S E R V I C E N O T E

16339A Component Test Fixture (SMD) Module

Modification to correct a missassembled arm plate.

Figure 1. Correction of the Arm Plate Direction

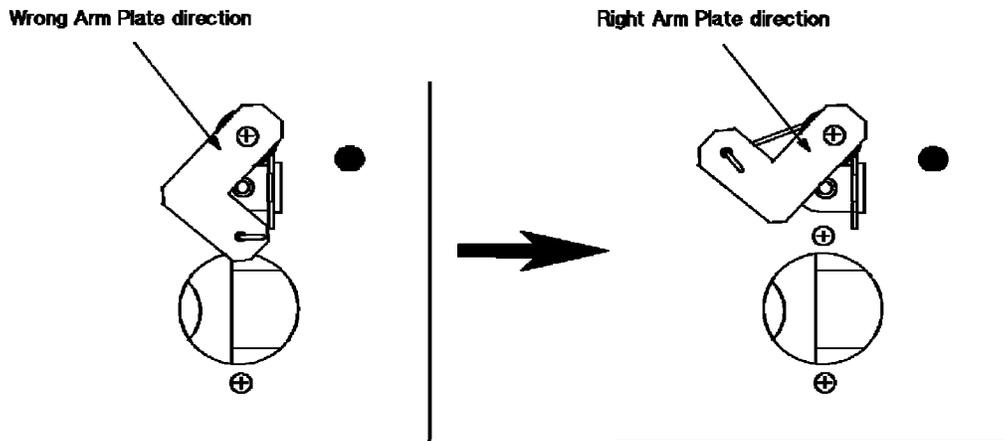
The arm plate inside of the SMD module may have been missassembled on above serialized 16399A. It can shorten the spring's life.

1. Loosen the three screws on the shield cover which is placed on the back of the SMD module. Then, remove the shield cover.
2. Check the arm plate direction by referring to Figure 1. If the arm plate is attached in the wrong direction, then perform the following steps.
3. Removed the screw which attaches the lever with holding the lever from the face of the SMD module.

The solution involves reassembling the arm plate correctly.
